PLANNING APPLICATION

PROJECT / LOCATION		DRAWING	
PLEMONT BAY HOLIDAY VILLAGE PLEMONT 28 HOUSES DEVELOPMENT		HOUSE 13 FIRST FLOOR PLAN SECOND FLOOR PLAN	
CLIENT	DRAWN	CHECKED	
PLEMONT ESTATES LTD	PAP	PH	
DATE	SCALE	DRAWING NUMBER	
JUNE 2010	1:50 @ A0	1871/G/02	D

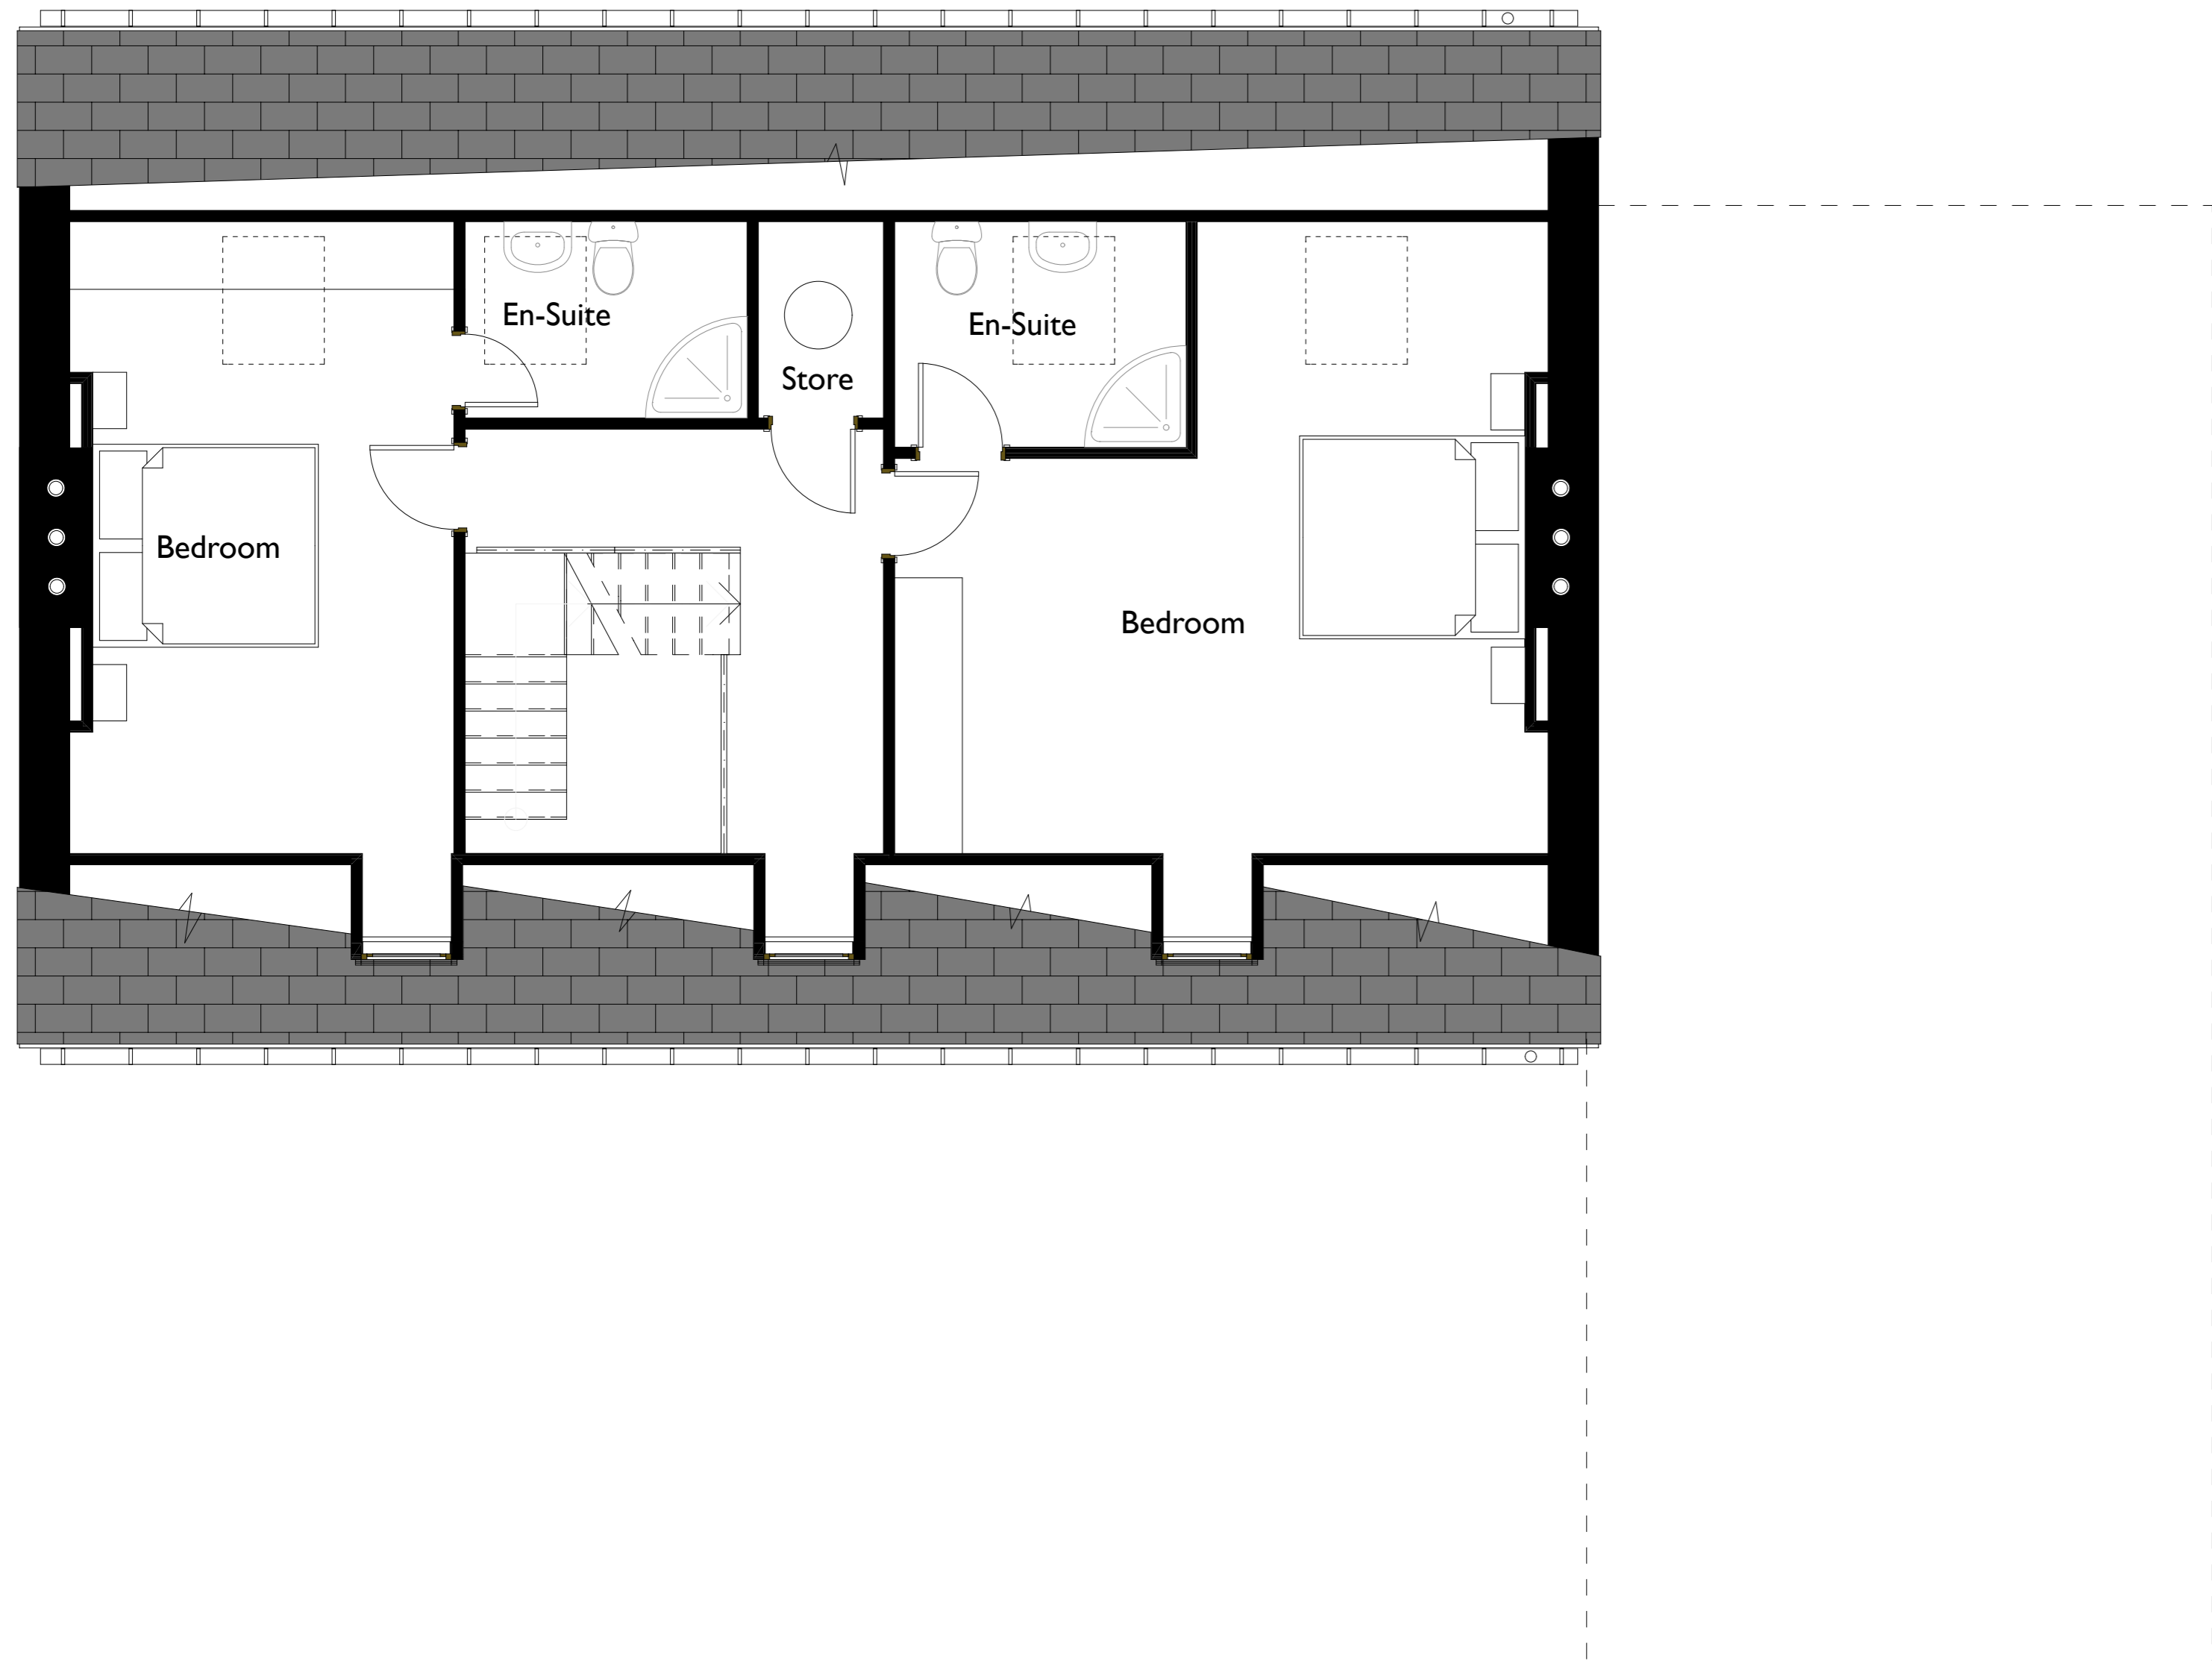
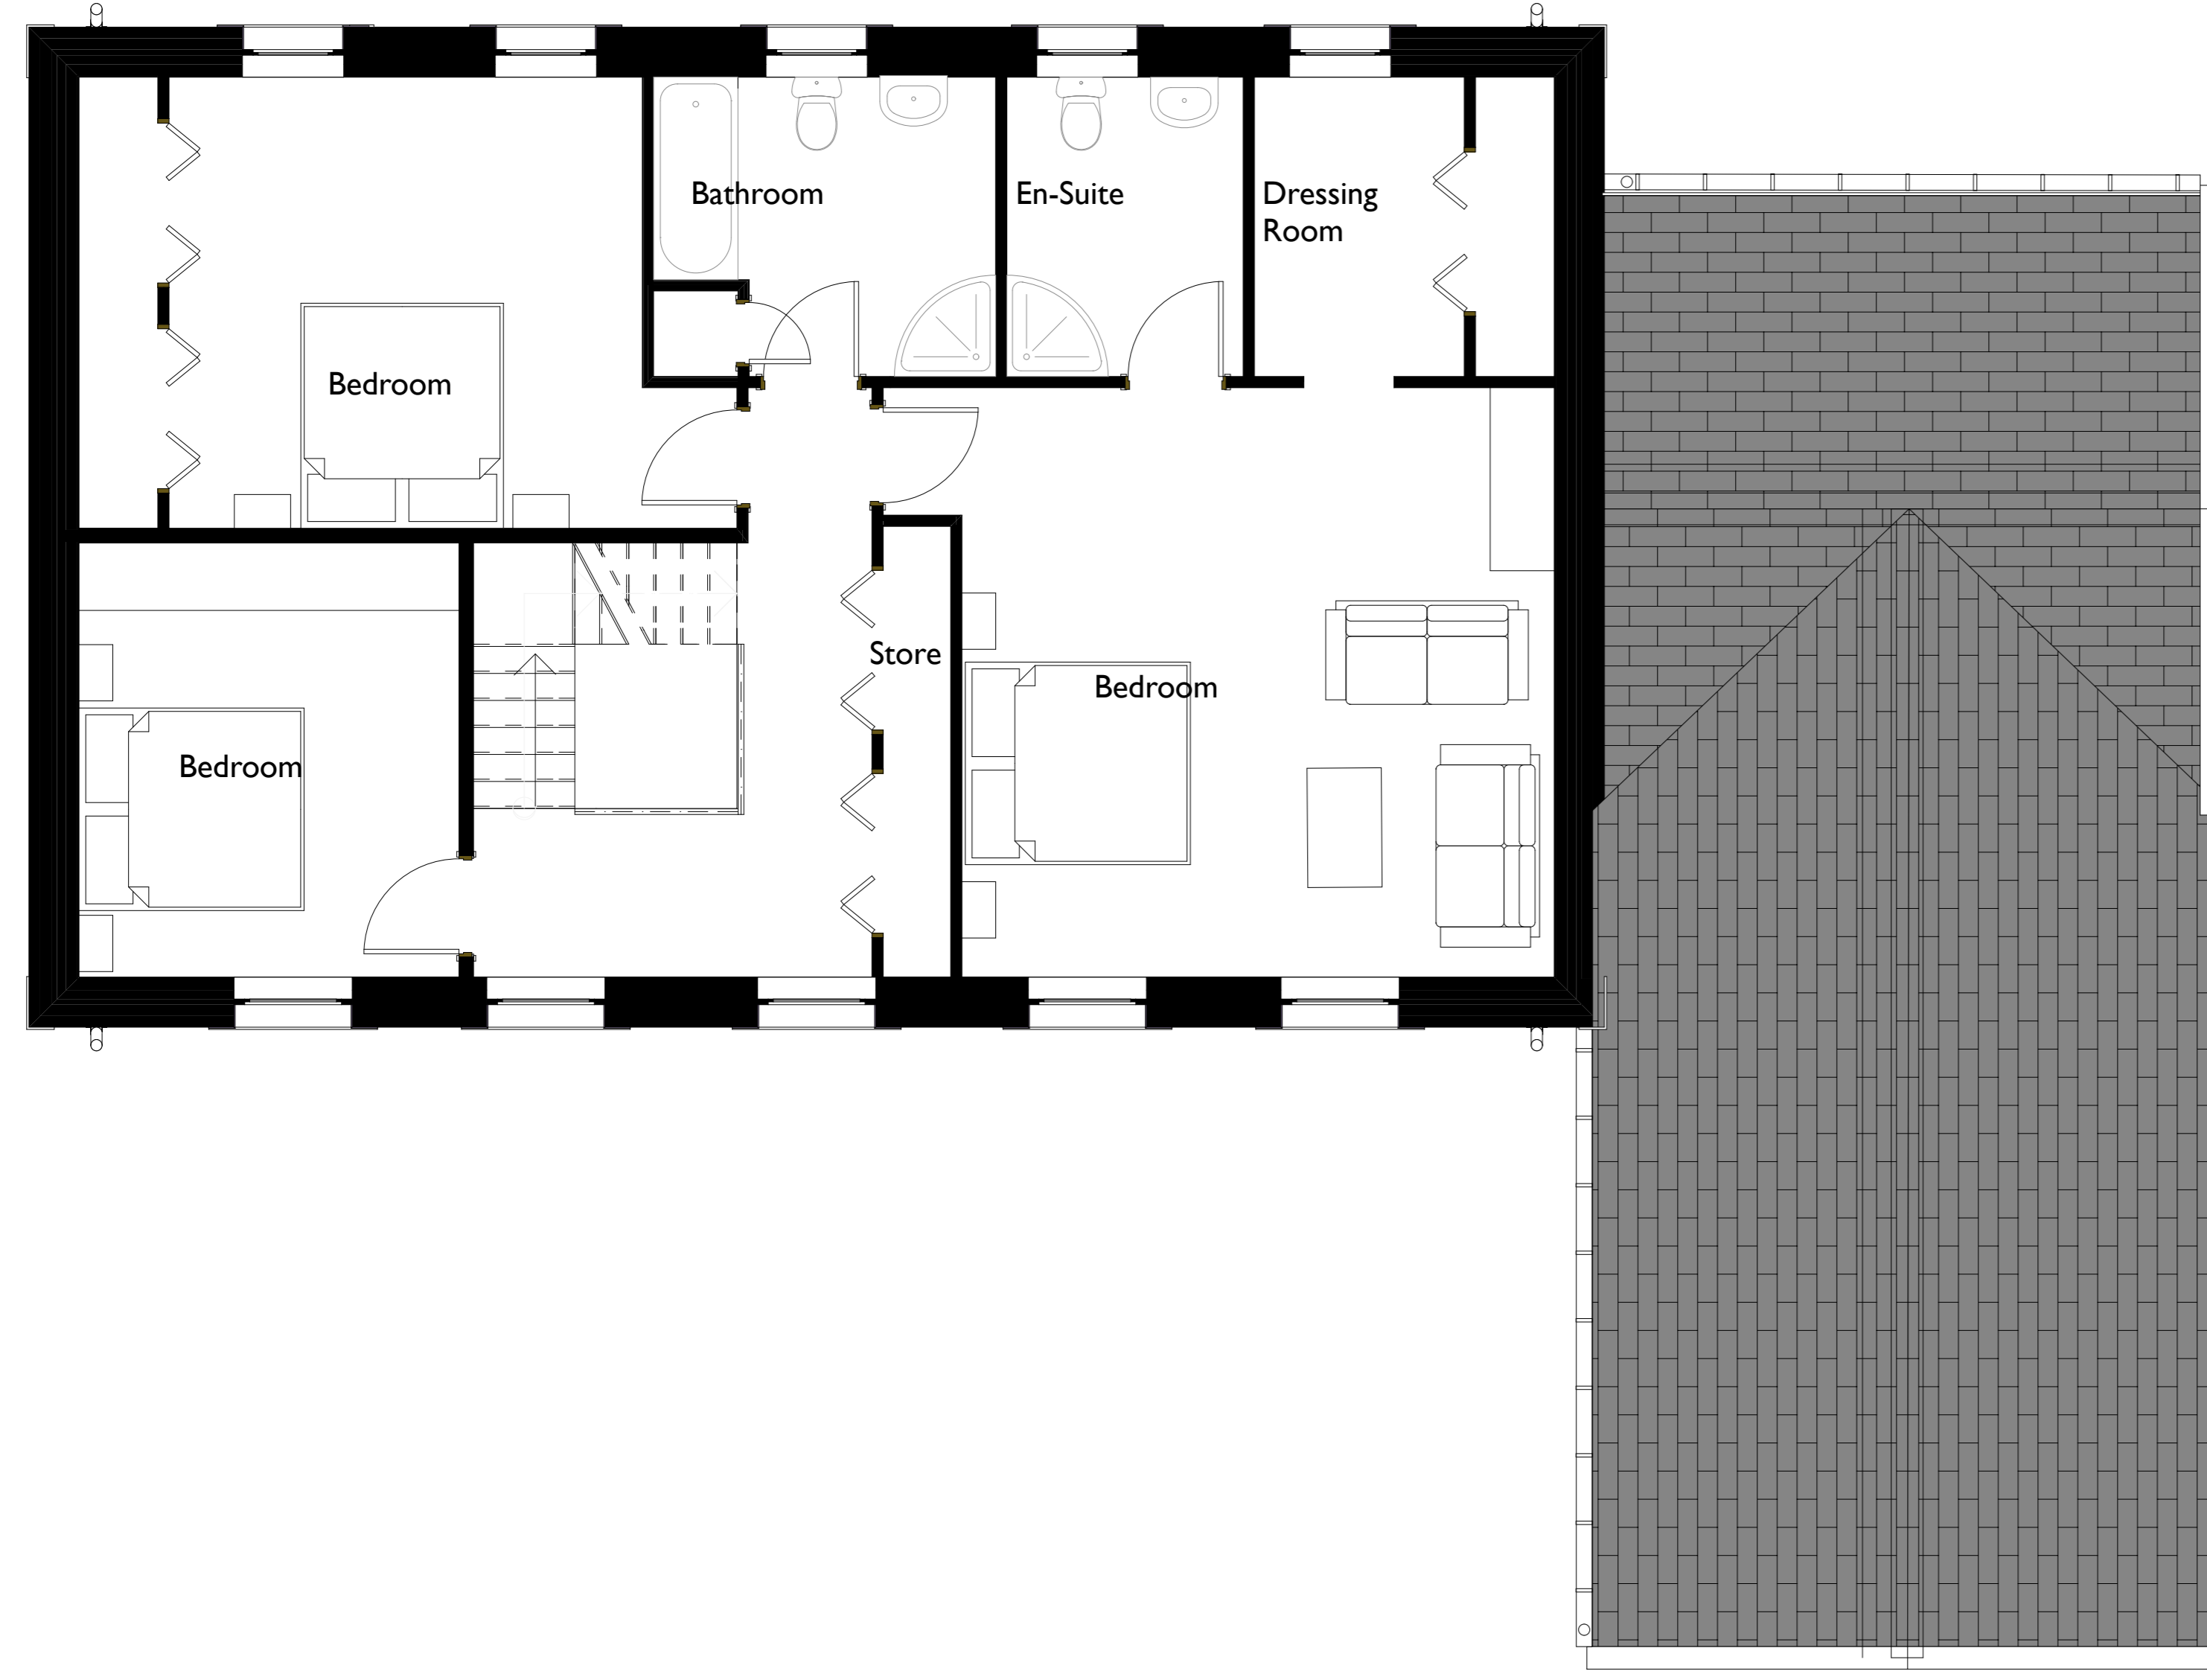
A	June 2010	Scheme revised as directed by Planning Department & to Planning requirements	PAP
B	July 2010	House elevations revised to Planning requirements	SB
C	Sept 2010	Revisions to further Planning requirements: a) Ridge tiles changed from terracotta to slate b) Roof windows reduced in size c) Dormers- reduced width and cheeks d) SW (front) windows resized e) SE elevation upper gable window and timber cladding band removed, height of gable reduced to level ridge with garage, lounge patio doors & sidelights replaced with double patio doors	PM
D	Sept 2010	Revision to further Planning requirements: A.) Small gable over lounge doors removed and roof re-positioned.	PAP
